1901 Gratiot Street, St. Louis

ULNRC-1472

DOCKET NUMBER 50-483
CALLAWAY PLANT
RESPONSE TO NRC SAFETY EVALUATION
OF TOPICAL REPORT WCAP-10858
"AMSAC GENERIC DESIGN PACKAGE"

PLANT-SPECIFIC DESIGN DETAILS REGARDING
ATWS MITIGATING SYSTEM ACTUATION CIRCUITRY
CALLAWAY PLANT AND
WOLF CREEK GENERATING STATION

**FIG. 1 CONCEPTUAL DESIGN AND
LAYOUT OF AMSAC**

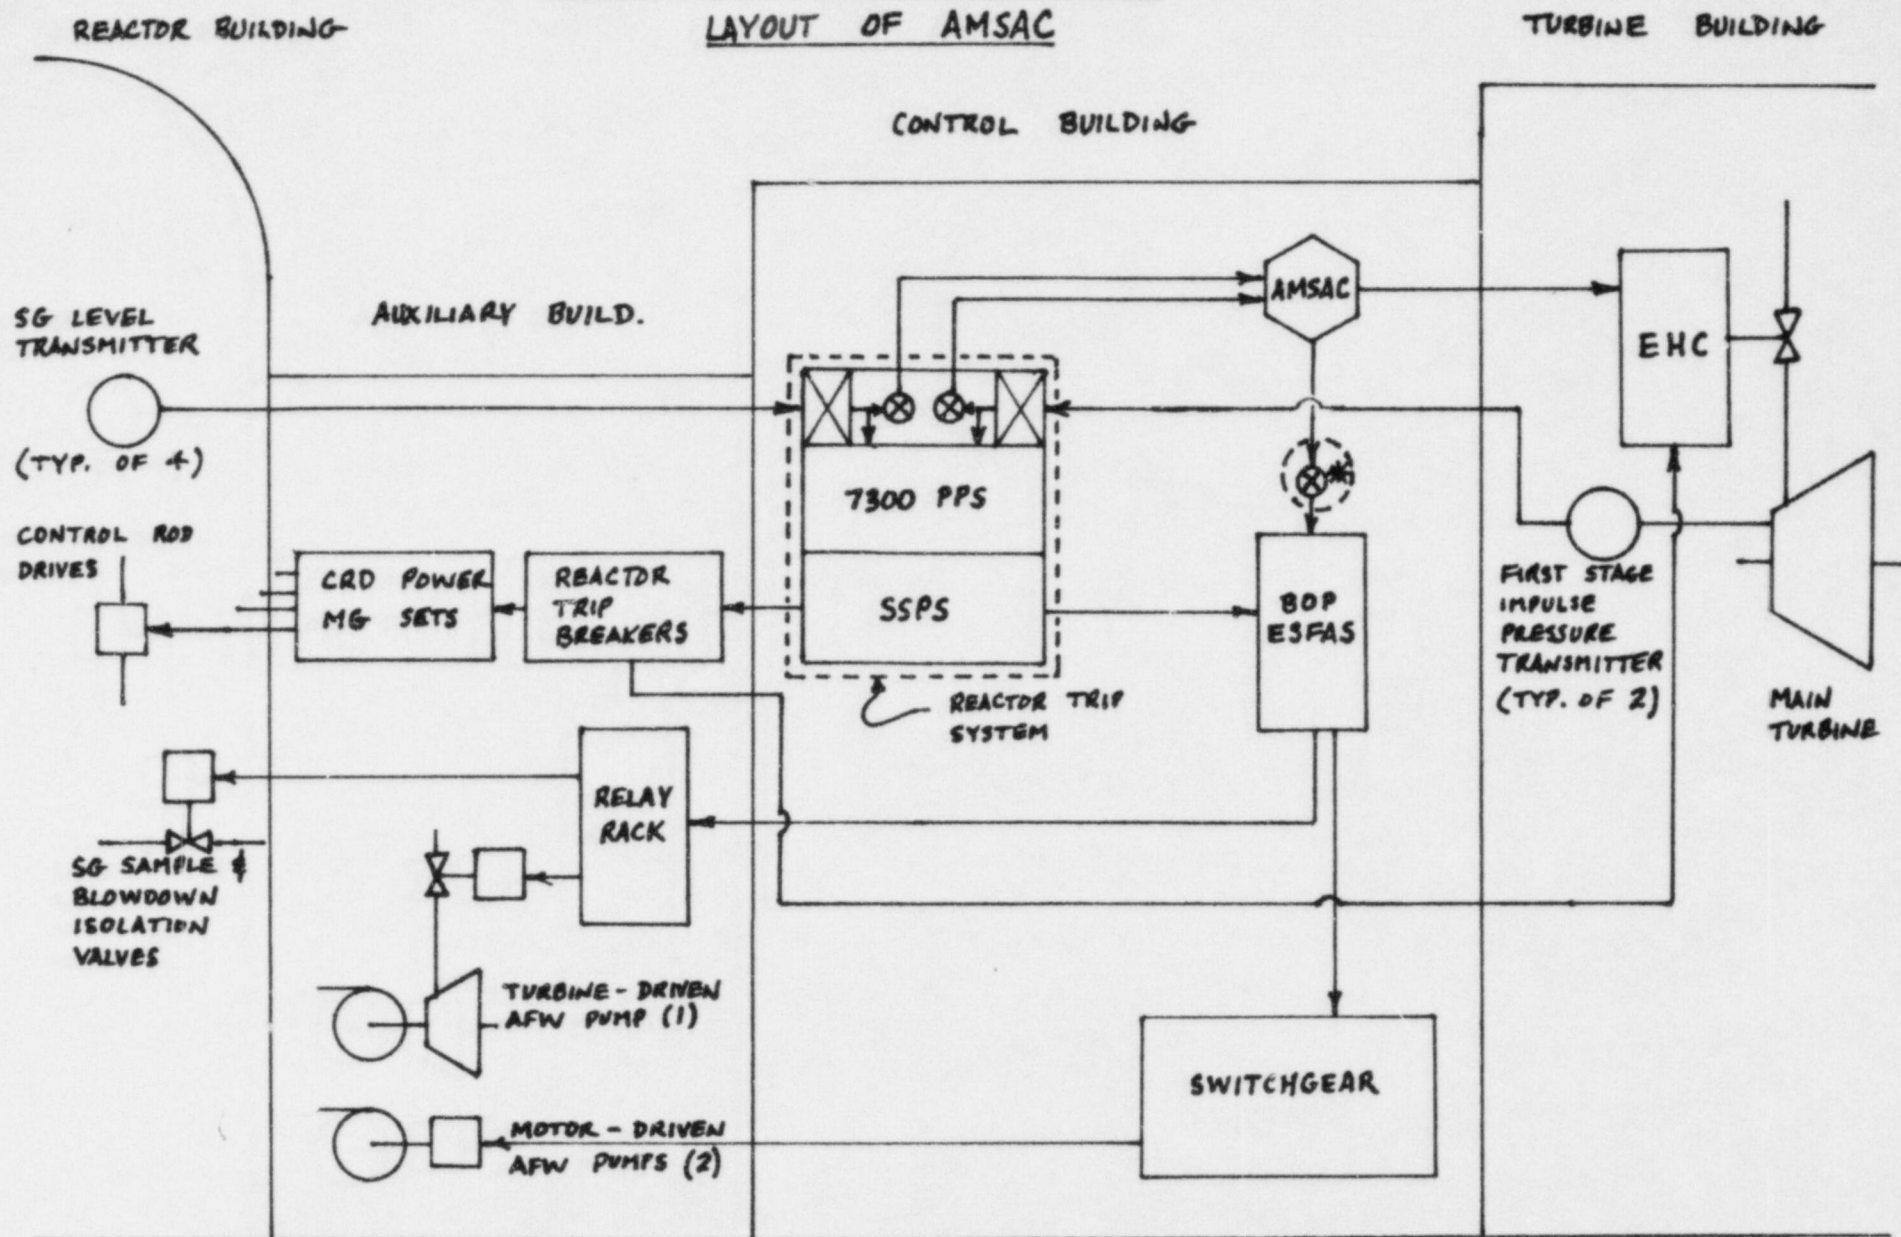
Physical separation from existing reactor protection system is not required, unless redundant divisions and channels in the existing reactor trip system are not physically separated. The implementation must be such that separation criteria applied to the existing protection system are not violated. The plant-specific submittal should respond to this concern.

For the Callaway and Wolf Creek AMSAC design, an AMSAC logic cabinet will be installed in the Control Room. The space allotted for the cabinet was incorporated into the original design of the plants. Existing narrow range steam generator level transmitters, not used in the steam generator level control system, will provide signals to the non-Class 1E AMSAC circuits via qualified isolation devices. The coincidence logic for AMSAC initiation is 3/4 low steam generator level signals with one channel provided for each of the four steam generators.* Outputs from AMSAC will provide a signal to the BOP ESFAS through qualified, Class 1E isolation relays to start the AFW pumps. The AFW pump start signal will also close steam generator blowdown and sample isolation valves. This use of the existing BOP ESFAS system will provide for the required diversity from the RTS without further complicating the plant safety systems. AMSAC will also provide a signal to the main turbine electrohydraulic control (EHC) system for turbine trip. The auxiliary feedwater flow response time and turbine trip response time are consistent with Reference 1 requirements. Figure 1 provides the conceptual design and layout of the AMSAC.

The AMSAC equipment will be physically separated from the existing RPS, and cable routing for AMSAC will be completed using the separation criteria described in FSAR/USAR Section 8.3.1.4. This will ensure that physical separation criteria of existing protection systems are not violated. Figure 1 also provides information about physical separation.
